Access Compliance Report

Public Rights-of-Way

(Pedestrian Signals)

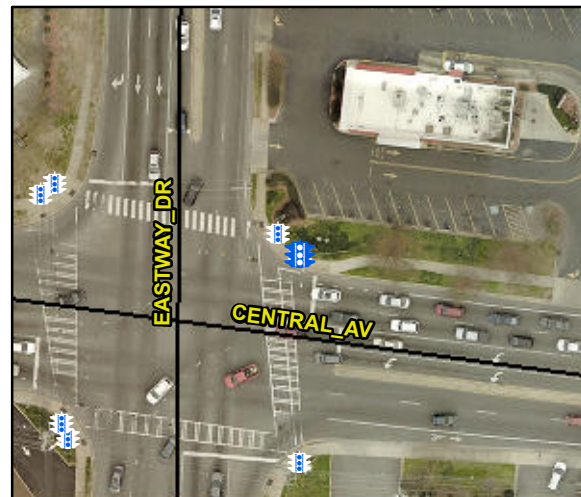
Surveyor Notes: TEXT HT 3/8

PROW/ADA: R410.6, TMUTCD 4e.08, R404.2, R404.3, R406.2, R209.1, MUTCD 4e.10

Yes	B 1 Clear Xing Direction?	ClearlyMarked	N/A	B 2 Clear Xing Direction?	N/A
	B 1 Crossing Direction	To S		B 2 Crossing Direction	N/A
Yes	B 1 DistanceTo XWalk (in)	24.0	N/A	B 2 DistanceTo XWalk (in)	N/A
No	B 1 DistanceTo Curb (in)	84.0	N/A	B 2 DistanceTo Curb (in)	N/A
Yes	B 1 Diameter (in)	2.0	N/A	B 2 Diameter (in)	N/A

Possible Solutions: Replace Signal Push Button With APS Button on New Post. Remove & Replace Sign.
